## SERVICE BULLETIN

SUBJ: HB4T HOT BOX DISPLAY CAN WIRING ADDED TO DISPLAY

**Machine Model:** HB4T

**Serial Numbers:** 469697-482350

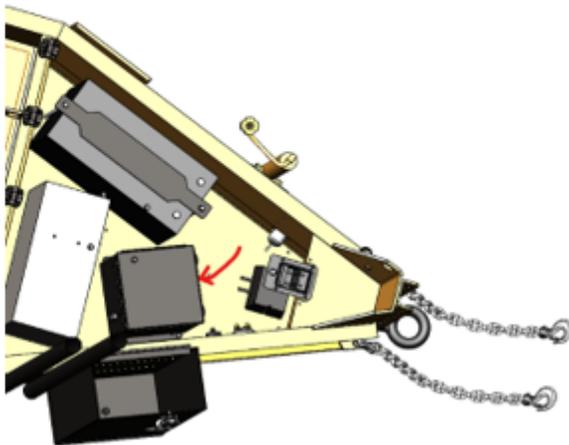
Need to add the pigtail wire and plug to update code in the display. The part needed is being shipped to dealers by serial number to speed up the process. After installing the pigtail wire, the service tech will need to have the Plus One service tool while contacting Rapid Response to upload the latest code to the display.

Some units have been reported to not heat material to the required temperature. Once actions are completed, the unit will operate as intended and heat material effectively.

Locate control box inside the tongue of the trailer and open the lid.

Remove 12-pin connector from display.

Remove wedge from connector with needle nose pliers.

Remove hole plugs from pins 3 and 4.

Insert Yellow wire with terminal into pin 3. Green wire into pin 4.

Install wedge that was removed back to 12-pin and plug connector back into the display.

Insert Plus 1 Danfoss service tool dongle into the open cavity on the wye connector. (make sure service tool dongle has a 120-ohm resistor)

Contact Rapid Response and use team viewer to update software to Version 102.
